## COUNCIL ASSESSMENT REPORT

<b>Panel Reference</b>	2017SNH072
<b>DA Number</b>	DA326/17
<b>LGA</b>	North Sydney
<b>Proposed Development</b>	<b>Construction of 5-storey health facility with lower ground level parking for 11 cars, demolition of ancillary buildings to permit vehicle driveway, earthworks, associated landscaping, conservation works to Carpenter House</b>
<b>Street Address</b>	25 Shirley Road, Wollstonecraft
<b>Applicant/Owner</b>	Tresillian Family Care Centres
<b>Date of DA lodgement</b>	18 September 2017
<b>Number of Submissions</b>	131
<b>Recommendation</b>	Refusal
<b>Regional Development Criteria (Schedule 7 of the SEPP (State and Regional Development) 2011</b>	<b>Private infrastructure and community facilities over \$5 million</b>
<b>List of all relevant s4.15(1)(a) matters</b>	<ul style="list-style-type: none"> <li>• North Sydney Local Environmental Plan 2013</li> <li>• Rural Fires Act 1997</li> <li>• State Environmental Planning Policy (Infrastructure) 2007</li> <li>• State Environmental Planning Policy No. 55 – Contaminated Lands</li> <li>• Sydney Regional Environmental Plan (Sydney Harbour Catchment) 2005</li> <li>• Integrated Development</li> <li>• North Sydn

*Figure 2 – Plans & elevations of the proposed building*

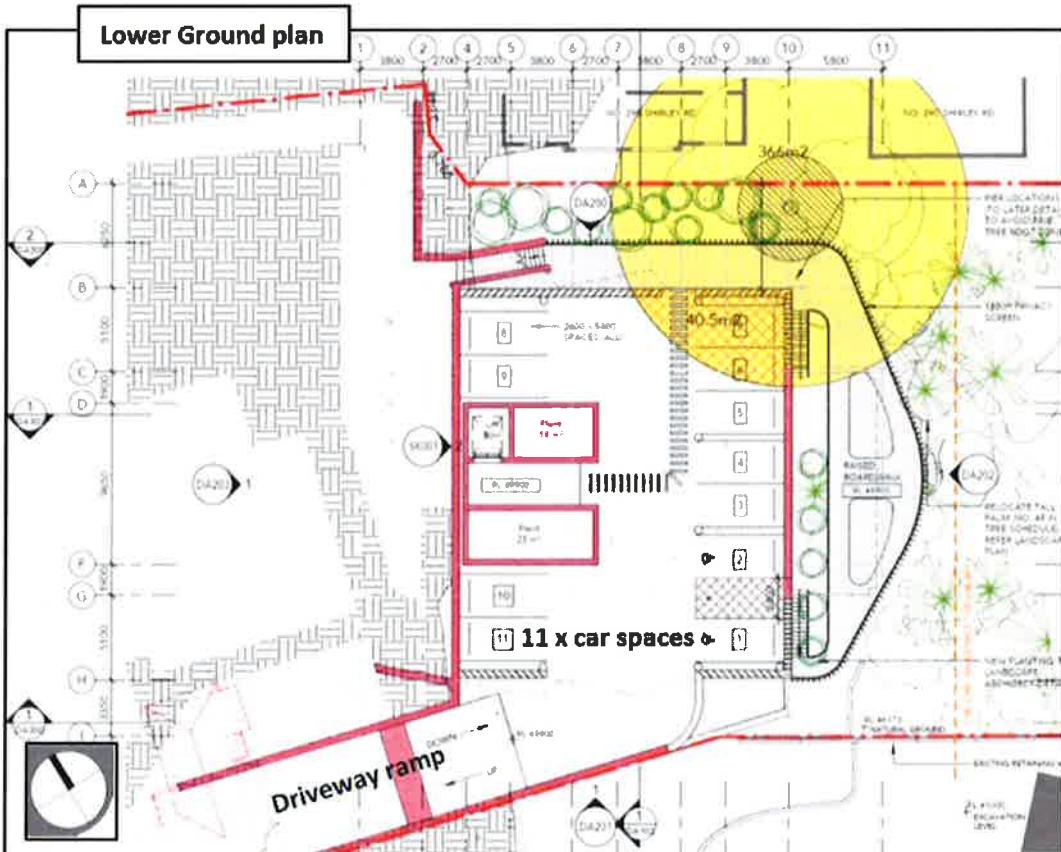
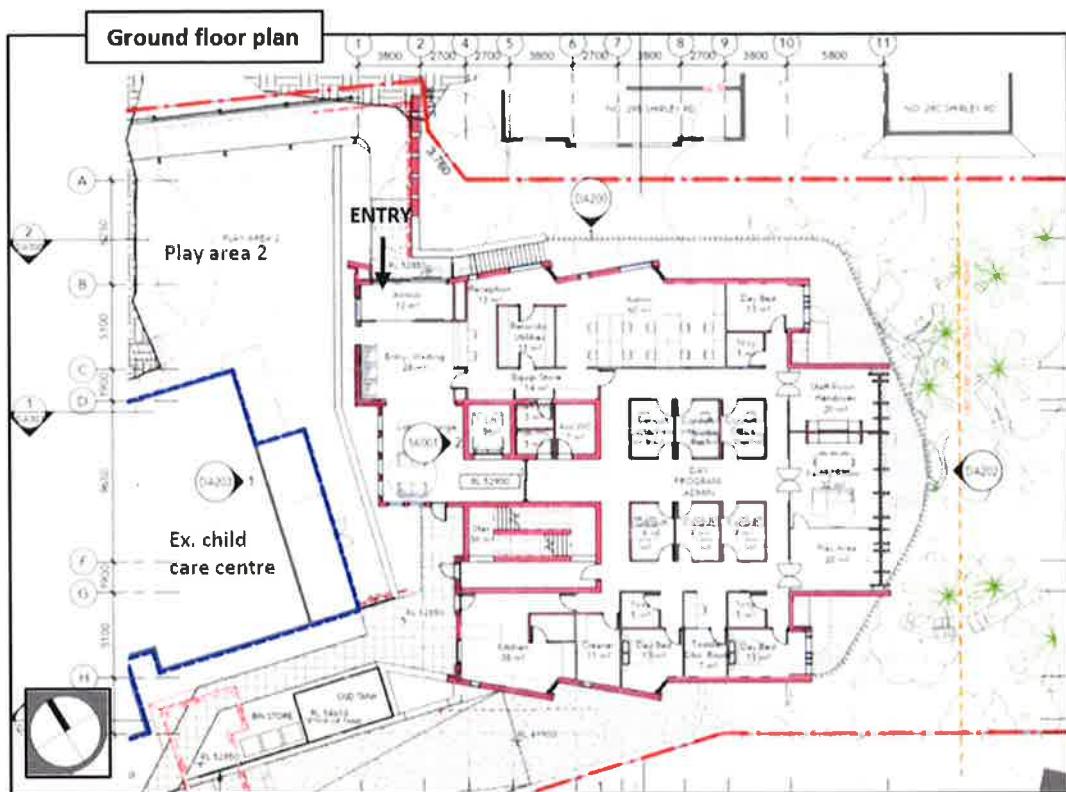
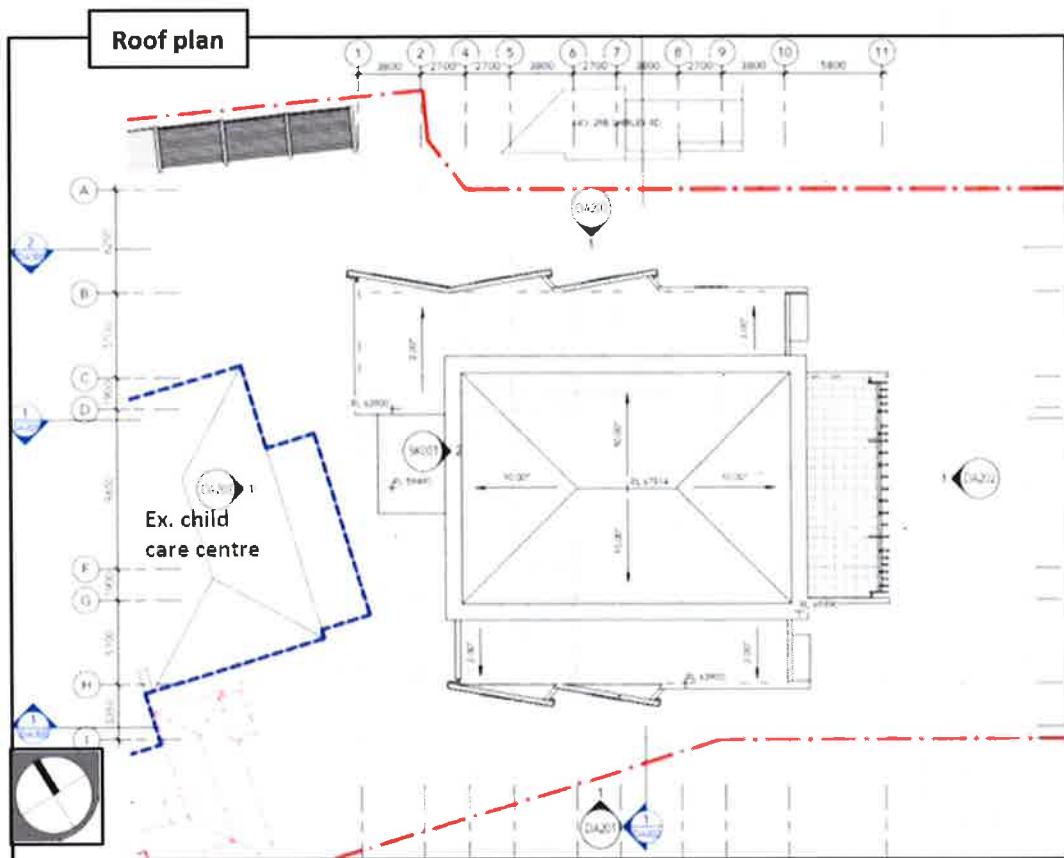
It is considered that the floorplate, setbacks and height of the new building do not respond appropriately to the site constraints, in particular, the proximity of adjoining dwellings and the fall of the land. Furthermore, it is considered that there is scope to redistribute useable floor areas to the undercroft or void spaces within the new building to reduce the apparent bulk and scale of the building and its amenity impacts.

**Planner's comment:** The application has not been amended to address the concerns of the Panel in relation to the visual bulk of the building. No change is proposed to the height and setback of the south eastern corner of level 2 which remain as originally proposed. It is considered that the development as currently proposed does not address the issues raised by the Panel.

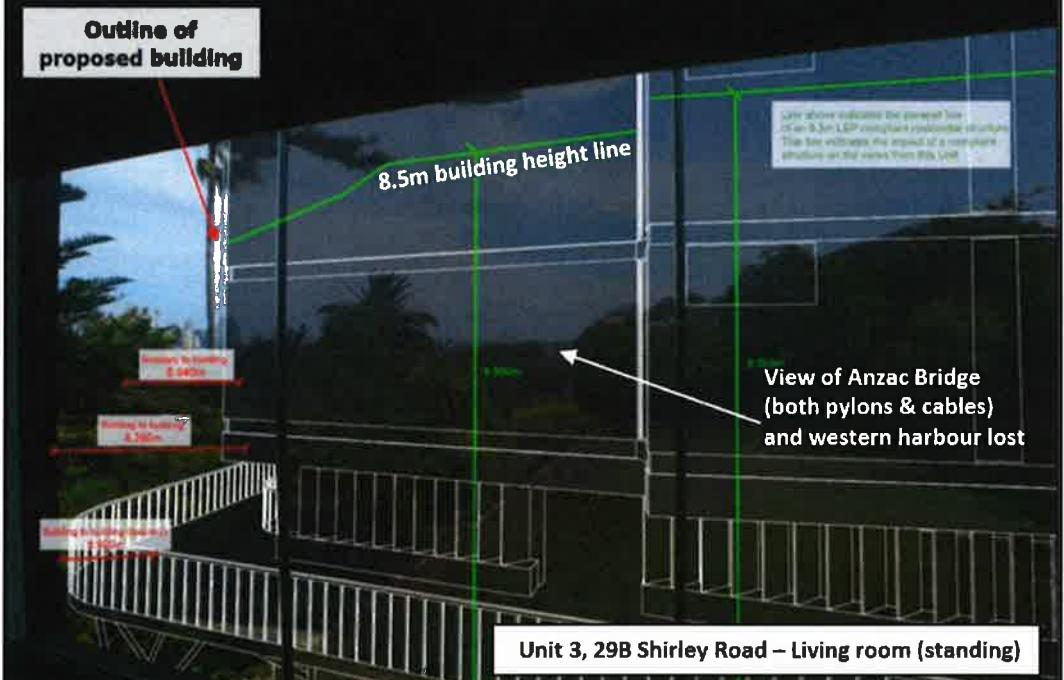
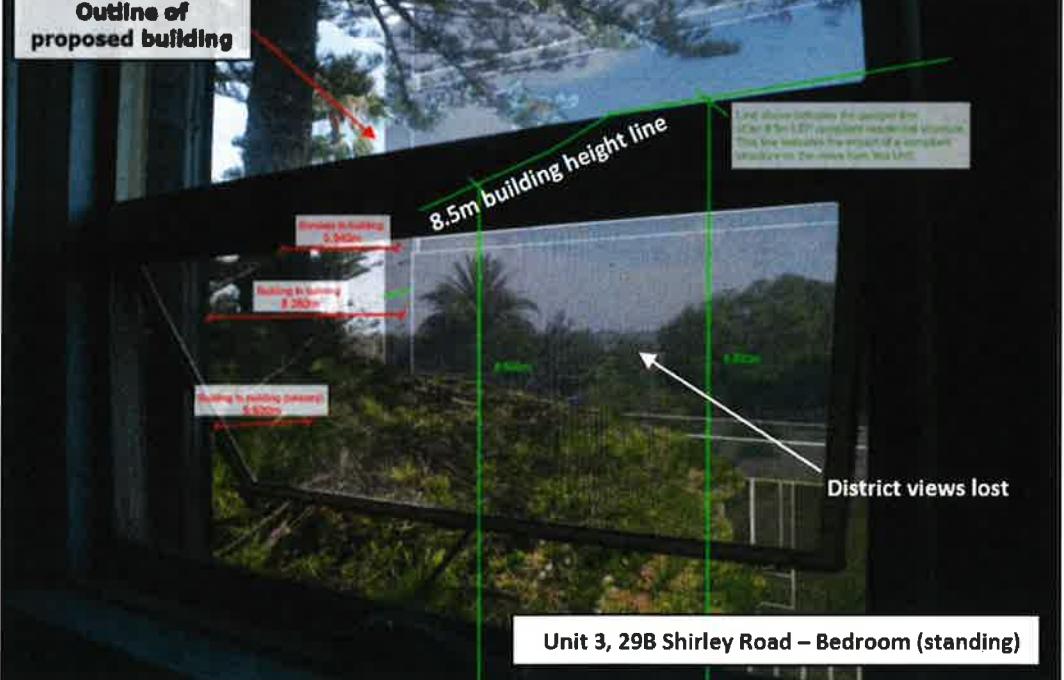
Identification of views and extent of impacts	
<b>Unit 3 – 29A Shirley Road</b>	
<p>The development will result in the loss of views to part of the Anzac Bridge (including a pylon and cables), and part of the Pyrmont skyline (Figure 11). The view is obtained at an angle from a standing position through the kitchen window, across the side boundaries of the subject site and through gaps in vegetation. A direct and immediate outlook to the landscaped open space associated with the Guthrie Child Care Centre within the site will, however, be maintained.</p>

**Figure 18 – Townhouse units at 24 Tryon Avenue located south of the proposed new building**

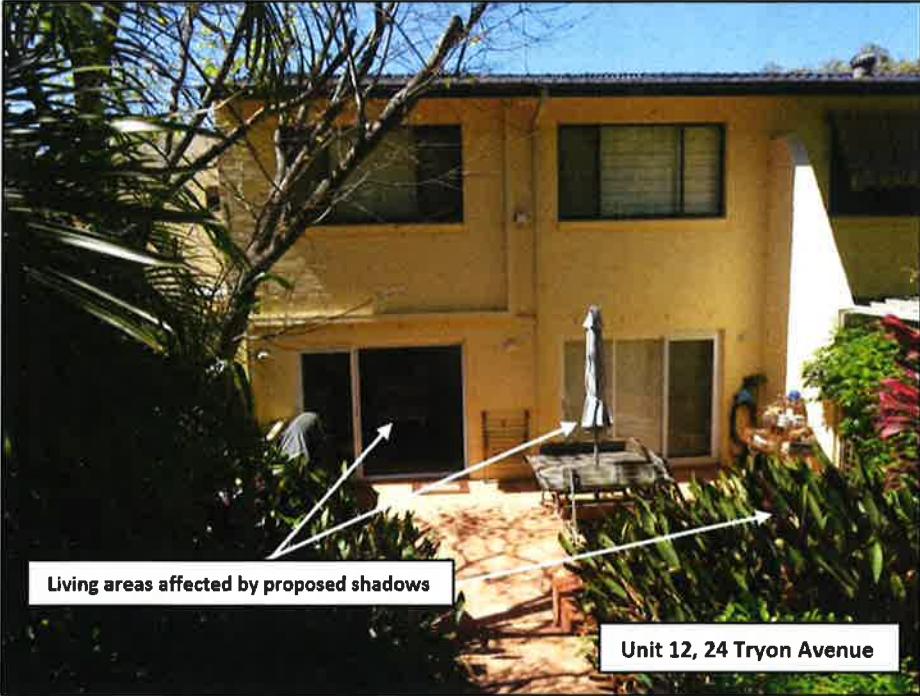
<i>Assessment of shadow impacts</i>
<b>Density</b>
The site is located in an area characterised by medium density housing, being immediately adjoined by 2- & 3-storey walk up units, and 2-storey townhouses at No.24 Tryon Avenue to the south/southeast.
<b>Overshadowing by fences, roof overhangs and changes in level</b>
<p>Shadows cast by vegetation are not included. The shadow-affected townhouses at No.24 Tryon Avenue are located some 8.7m below the area of the site proposed to be occupied by the proposed new building.</p> <p>The rear gardens of Townhouse Units 11 &amp; 12 are subject to extensive self-shadowing by the existing landscaped terrace, retaining wall and fencing.</p> <p>Shadows cast by Carpenter House and neighbouring residential flat buildings are also accounted for in the submitted shadow diagrams.</p>
<b>Identification of additional shadows &amp; extent of impacts</b>
The proposed development will result in shadow impacts on townhouse <b>Units 11, 12, 13 &amp; 14 of No.24 Tryon Avenue</b> . The townhouses are located to the south of the proposed building ( <b>Figure 18</b> ) and some 8.7m below the development site.

<i>Figure 24 – Maximum 8.5m height control for Wollstonecraft peninsula</i>

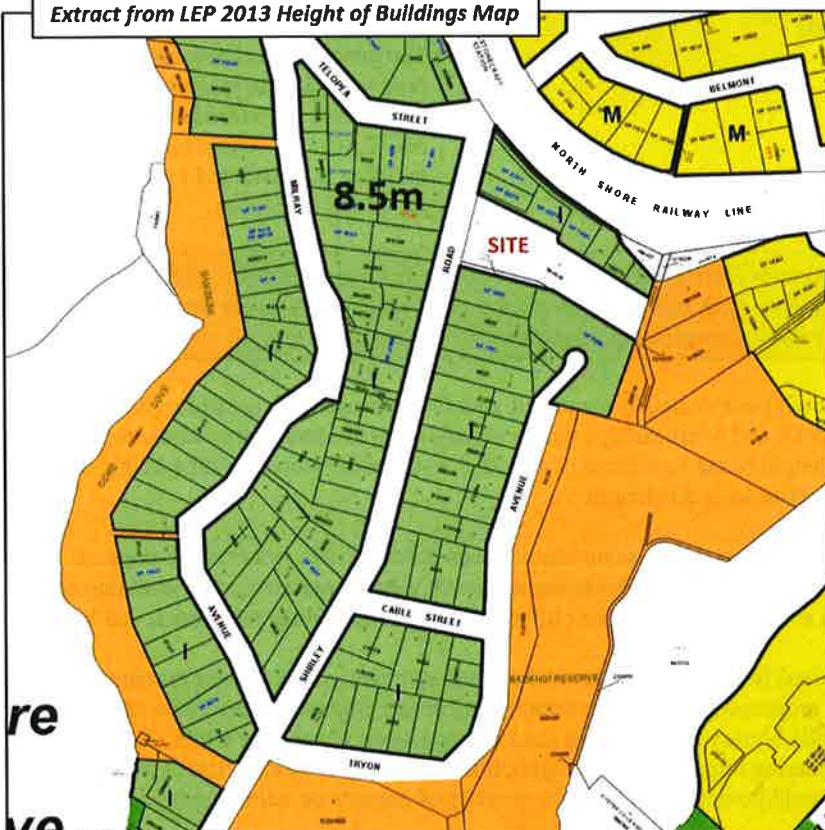
<p>The proposed 16m parapet height is 7.5m higher than (more than two building storey in excess of) the prevailing predominantly low scale 2- &amp; 3-storey walk up residential flat buildings built form character of the area which reflects the 8.5m building height control (<b>Figure 23</b>).</p>		
<p>The apparent bulk of the new building is attributable in large part to the proposed parapet up to 16m in height, 26m long northern façade, proximity of existing adjoining apartment buildings to the north, and the fall of the land to the rear (east).</p>		
<p>The proposed building is significantly larger than characteristic buildings and does not complement the existing character of the area, contrary to DCP Section B3.3.7 in relation to form, massing and scale.</p>		
<p>The concerns raised by the Design Excellence Panel with regard to the bulk and scale of the building and the impact on neighbours have not been adequately addressed.</p>

<b><i>How does the proposal's height and bulk relate to the height and bulk desired under the relevant controls?</i></b>		
<p>The proposed parapet height of up to 16m is 7.5m (88%) higher than the 8.5m building height control under LEP 2013 applicable to all adjoining lots and the Wollstonecraft peninsula in general and indicative of the desired height in the area (<b>Figures 24 &amp; 25</b>).</p>

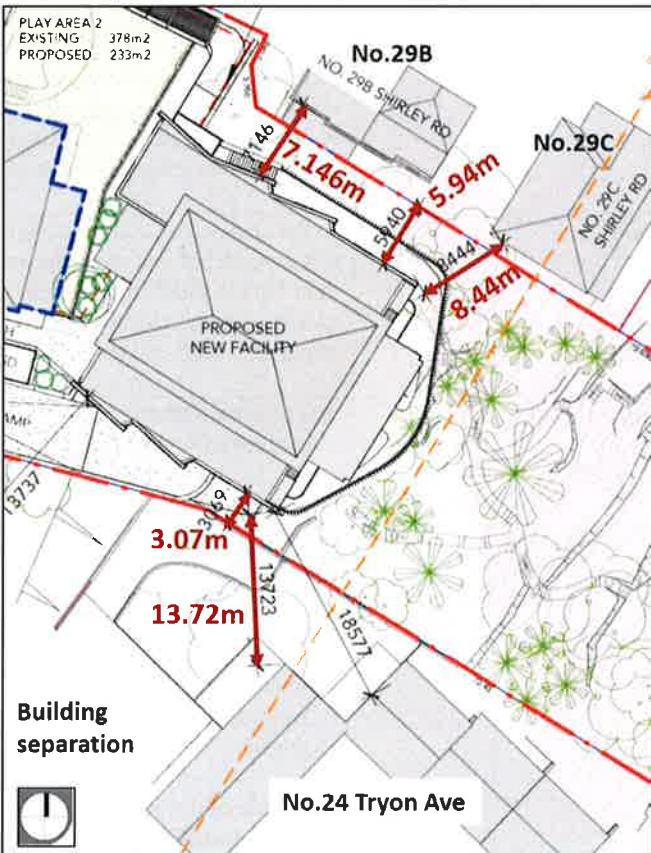
DEVELOPMENT CONTROL PLAN 2013		
Non-residential development in Residential zone	Complies	Comments
3.3.6 Setbacks (side) (continued)	No	<p><b>O2 To control the bulk and scale of buildings.</b></p> <p>The proposed bulk and scale of the building has been assessed to be unsatisfactory under the planning principles for the assessment of height and bulk established in <i>Veloshin v Randwick Council [2007]</i> NSWLEC 428, as discussed above in the <b>Context</b> section of this Compliance Table.</p>
	No	<p><b>O3 To provide separation between buildings.</b></p> <p>The proposed development provides for separations of at least 7.146m and 13.7m from the north- and south- adjoining dwellings (Figure 27).</p>
 <p>PLAY AREA 2 EXISTING 378m<sup>2</sup> PROPOSED 233m<sup>2</sup></p> <p>No. 29B No. 29B SHIRLEY RD</p> <p>No. 29C No. 29C SHIRLEY RD</p> <p>PROPOSED NEW FACILITY</p> <p>(3/37)</p> <p>13723</p> <p>18571</p> <p>18544</p> <p>5840</p> <p>7.146m</p> <p>5.94m</p> <p>8.44m</p> <p>3.07m</p> <p>13.72m</p> <p>No. 24 Tryon Ave</p> <p>Building separation</p>

- (a) The proposed setbacks do not adequately control the bulk and scale of the new health services building, contrary to **Objective O2 of Section B3.3.6 Setbacks** in North Sydney DCP 2013.
- (b) The setbacks of the new building do not provide for adequate separation from adjoining dwellings, contrary to **Objective O3 of Section B3.3.6** in North Sydney DCP 2013.
- (c) The provision of inadequate setbacks, particularly at the parapet level, results in unacceptable shadow, view and overbearing impacts on adjoining dwellings, contrary to **Objective O4 of Section B3.3.6** in North Sydney DCP 2013.
